35/1~~3~~³-06GG 37 OXFORD ST
Chevy Chase Village Historic District

SUBJECT: Historic Area Work Permit #385729 ^{438933 NEW#} REVISION, driveway alterations

HISTORIC PRESERVATION COMMISSION STAFF REPORT

Address:	37 Oxford St, Chevy Chase	Meeting Date:	12/6/2006
Resource:	Contributing Resource Chevy Chase Village Historic District	Report Date:	11/29/2006
Applicant:	Bruce Becker & Natalie Jennings	Public Notice:	11/22/2006
Review:	HAWP	Tax Credit:	N/A
Case Number:	35/13-06GG	Staff:	Michele Oaks
PROPOSAL:	Driveway Alterations

Revision

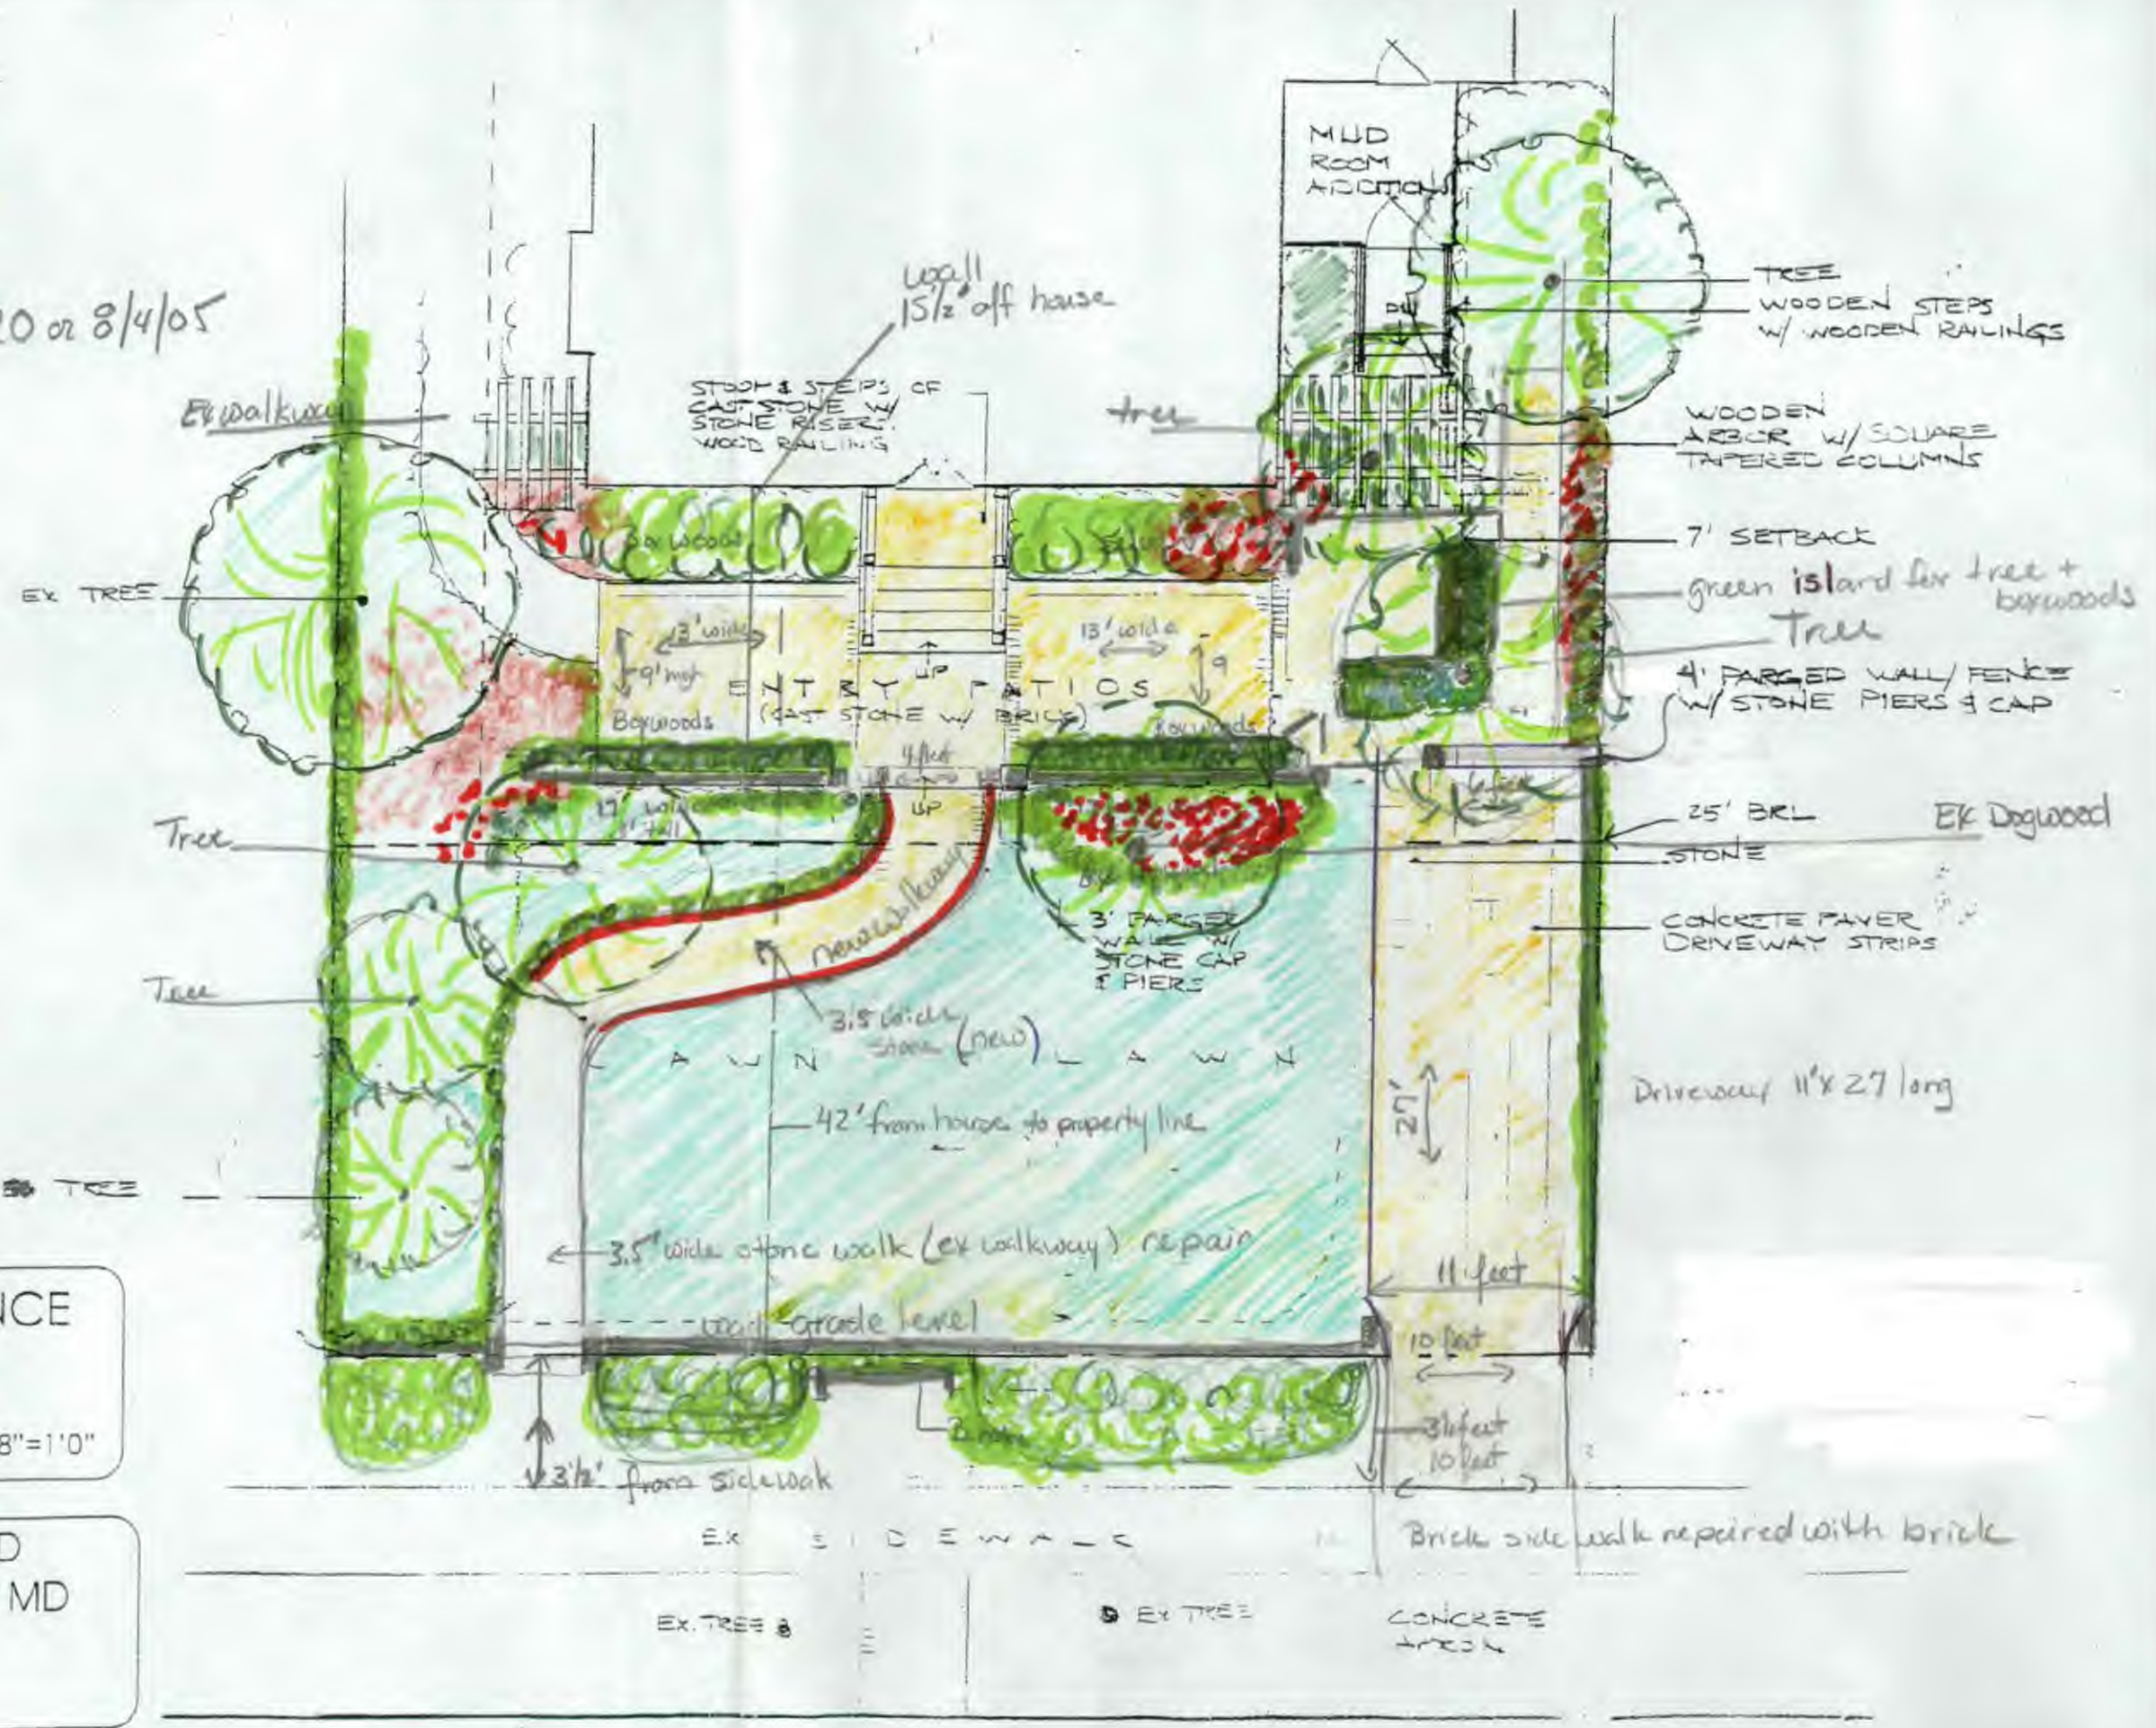
The applicant is proposing an 11' wide driveway. The driveway width will narrow within the ROW to 10' and will expand to form the concrete apron. This hourglass shape is typical within Chevy Chase Village.

The current driveway is fabricated with concrete wheel paths separated by sod. The owners are proposing a solid surface concrete driveway framed in brick. The owner has provided the attached 1920 landscape plan suggesting the original driveway was a solid surface material. Staff does agree that the plan does show a solid driveway, however, the original driveway surface material cannot be determined from the grainy photos on the plan.

The applicant has also proposed a modification to reduce the width of the entry patio by a foot and to bring the 4' high parged wall/fence with stone piers 6' closer to the front property line. Staff does not object to these alterations, as they will not negatively impact the existing integrity of the landscape. We support these changes with the condition that the parged wall/fence will not exceed 4' in height, as the Commission does not approve any fences or walls that exceed 4' in height forward of the rear elevation of the house.

* New plans show more green space than 1920 or 8/4/05

The 4' high parged wall/fence with stone piers & cap may move 6' closer to the front property line, however, the height of the wall/fence combination will not exceed 4' from grade to the top of the structure.
